UNITED STATES PATENT AND TRADEMARK OFFICE

APPLICATION NO.	FILING DATE	FIRST NAMED INVENTOR	ATTORNEY DOCKET NO.	CONFIRMATION NO.
10/710,450	07/12/2004	Kevin W. Guernsey	2243.0	4449
9748	7590	06/20/2005	EXAMINER	
LAITRAM, L.L.C. LEGAL DEPARTMENT 220 LAITRAM LANE HARAHAN, LA 70123			HESS, DOUGLAS A	
			ART UNIT	PAPER NUMBER
			3651

Office Action Summary

DETAILED ACTION

Fig. 5.

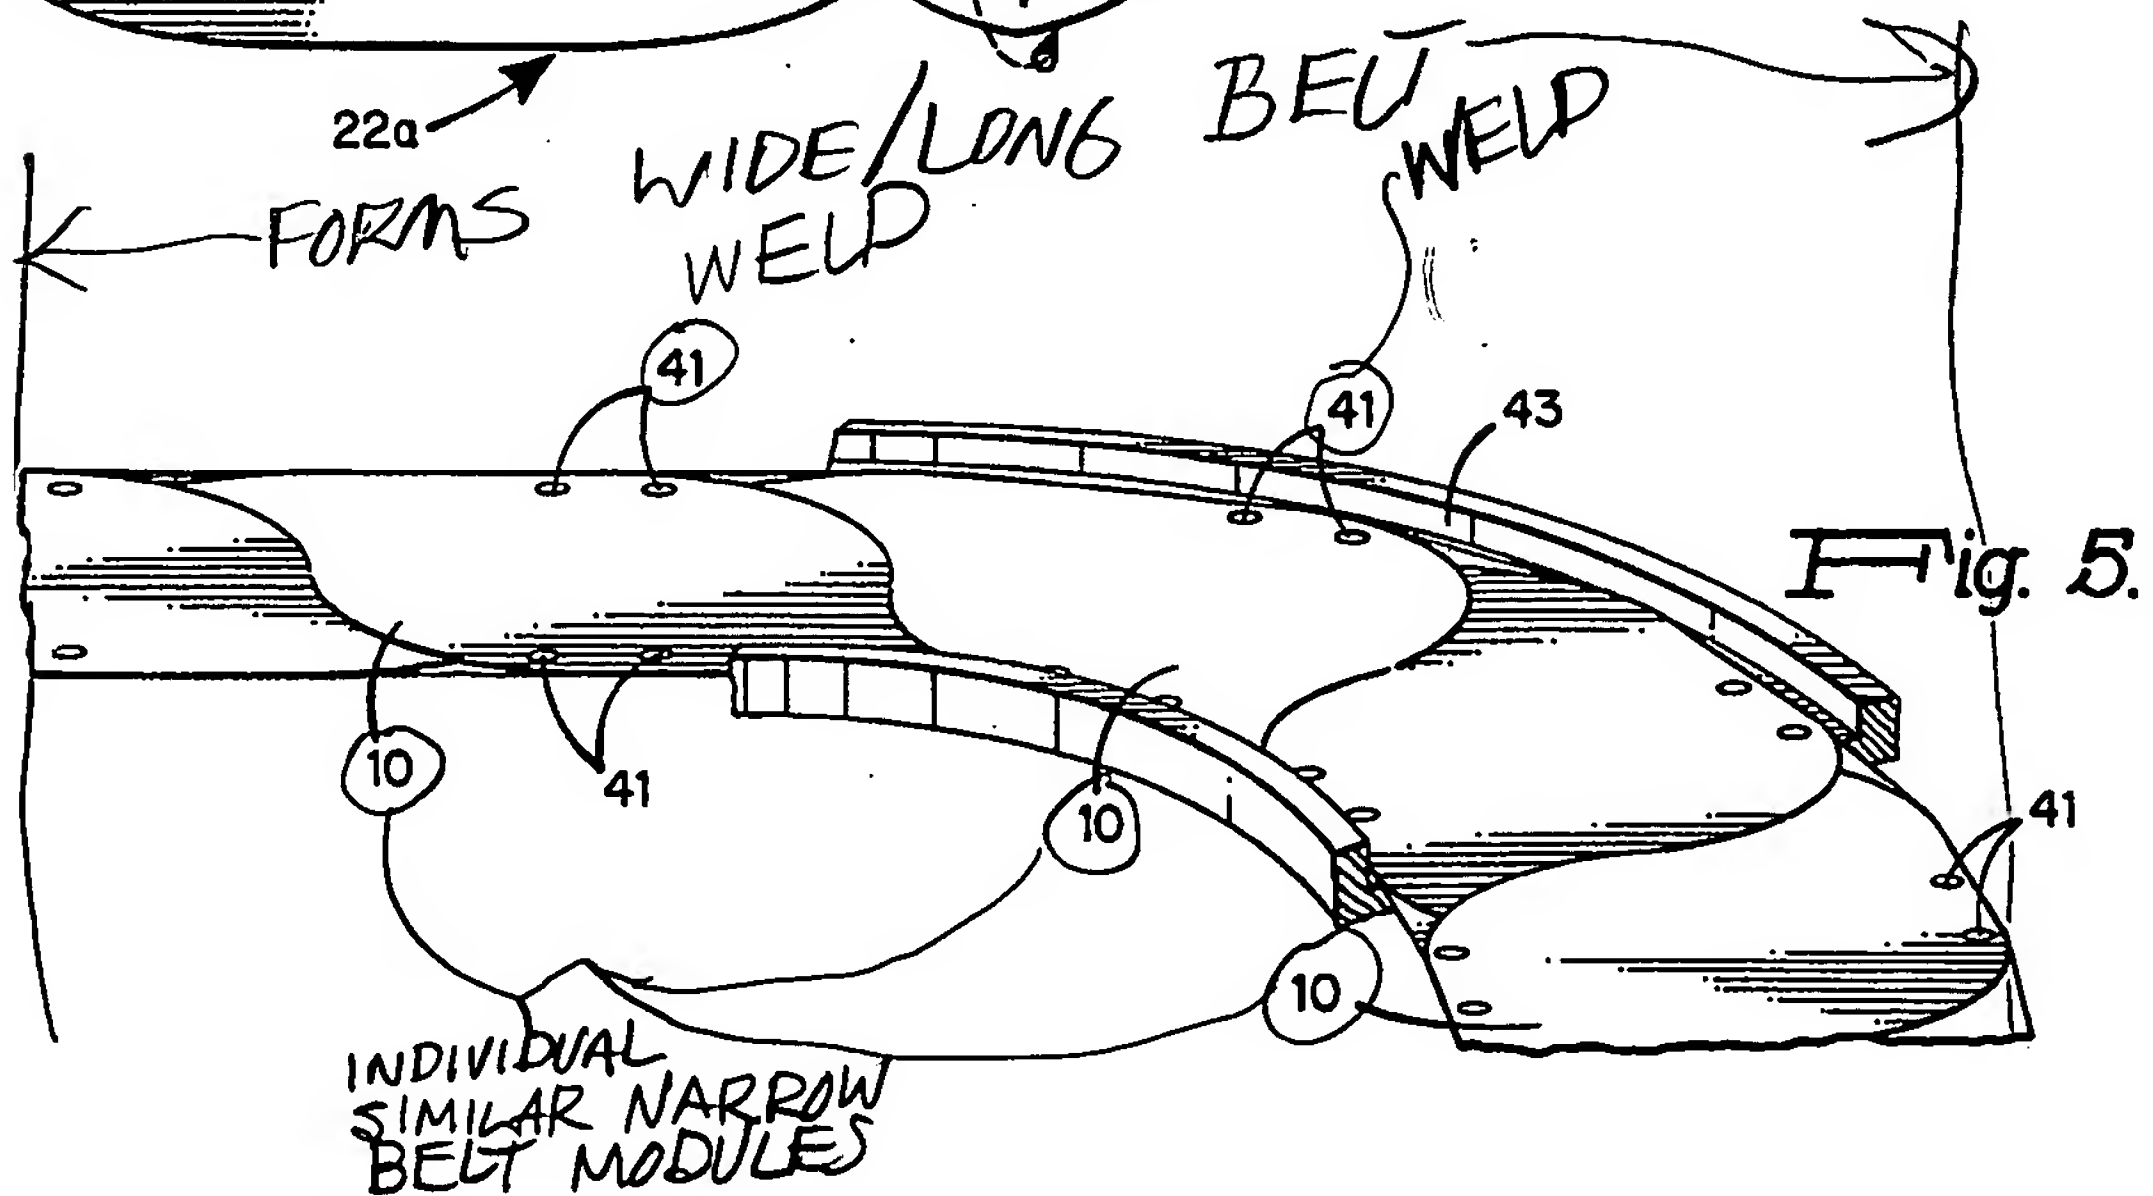
2. Claims 5 and 7 are rejected under 35 U.S.C. 102(b) as being anticipated by Lapeyre (US patent number 4,105,111).

See the attached marked up copy of Lapeyre figure 5.
